Virgil C. Summer Nuclear Station (VCSNS) Units 2 and 3  
Combined License Nos. NPF-93 and NPF-94  
Docket Nos. 52-027 & 52-028

Subject: LAR 15-09 R1 License Amendment Request: Use of AWS D1.1-2000 Criteria for Structural Welds

**Revised Request for License Amendment Regarding**  
**Use of AWS D1.1-2000 Criteria for Structural Welds**  
**(LAR 15-09 R1)**

Figure 1. Fillet Weld Loading In-Plane of Weld

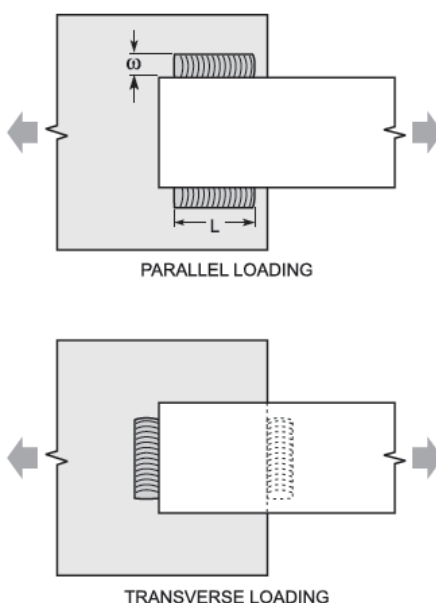
These changes are supported by industry tests that provide the justification for criteria that consider the load directionality. The testing and analysis is reported in an AISC Journal Article, *“Proposed Working Stresses for Fillet Welds in Building Construction,”* by T. R. Higgins and F.R. Preece. The referenced Higgins and Preece paper describes tests on linear fillet welds loaded both parallel to and transverse to the axis of the weld in the plane of the weld, as illustrated in Figure 1. The Higgins and Preece paper provides a factor of safety summary related to a working stress of  $0.30F_{EXX}$ . The summary of test results demonstrates that the failure of the weld loaded transverse to the axis of the weld is approximately four times  $0.30F_{EXX}$ .

For linear fillet weld groups concentrically loaded in the plane of the weld and consisting of elements oriented both longitudinally and transversely to the direction of applied load, additional provisions are proposed to be included in UFSAR Subsections 3.8.3.2 and 3.8.4.2 to supplement the provisions for directionality included in AWS D1.1-2000. These supplemental provisions address the deformation capability of the elements when combined in a weld group. The strength of the weld group is limited to the larger of (1) the combined strength of the individual weld elements using 1.0 times the strength of the longitudinally oriented element and 1.0 times the strength of the transversely oriented element and (2) the combined strength of the individual weld elements using 0.825 times the strength of the longitudinally oriented element and 1.5 times the strength of the transversely oriented element as illustrated in Figure 1A. These supplemental provisions are more conservative than those in AWS D1.1-2000 and are consistent with provisions in AWS D1.1-2010 Section 2.6.4.4 and Table 2.4 and AISC 360-2010 Section J2.4 (c).

Figure 3. Circular Fillet Weld Group

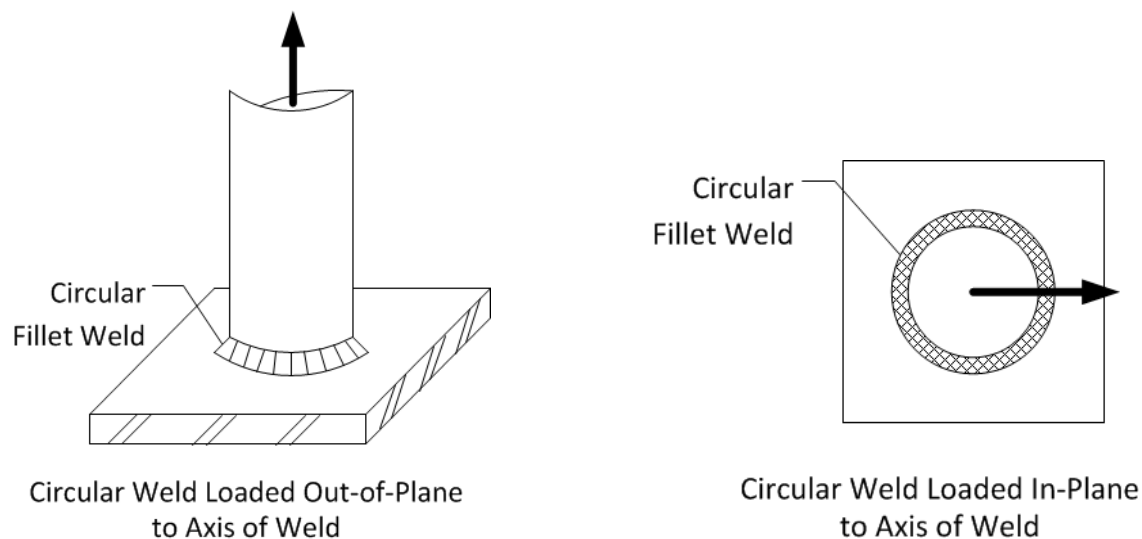
Circular fillet weld groups (e.g., fillet welds to anchor reinforcing bars, fillet welds to round rods, fillet welds to round tubes) are illustrated in Figure 3. A circular-shaped weld group concentrically loaded out-of-plane to the axis of the weld has a loading condition and behavior equivalent to a weld group consisting of straight lines because the shift in the fillet failure angle resulting in the increase in the strength of the weld occurs in the same way whether the axis of the weld is straight or circular. The parameter of interest is the angle that the applied force makes with the axis of the weld.

The use of directionality for circular welds is limited to tension loading concentrically applied out-of-plane to the axis of the weld. For circular welds loaded in-plane to the axis of the weld, the angle of loading measured from the weld longitudinal axis is constantly varying. Due to this complexity, application of AWS D1.1-2000 Section 2.14.4 is excluded for circular welds loaded in-plane to the axis of the weld. The limitation on the use of directionality to out-of-plane load for circular weld groups is included in the licensing basis changes in UFSAR Subsections 3.8.3.2 and 3.8.4.2.

- Where directionality is considered for concentric out-of-plane loading for linear fillet weld groups, including lines and rectangular configurations, the directionality provisions in AWS D1.1-2000 are applied.
- Where directionality is considered for concentric out-of-plane loading for circular-shaped fillet weld configurations, the directionality provisions in AWS D1.1-2000 are applied. The use of directionality provisions in AWS D1.1-2000 for circular-shaped fillet weld configurations is limited to tension loading concentrically applied out-of-plane to the axis of the weld.]\*
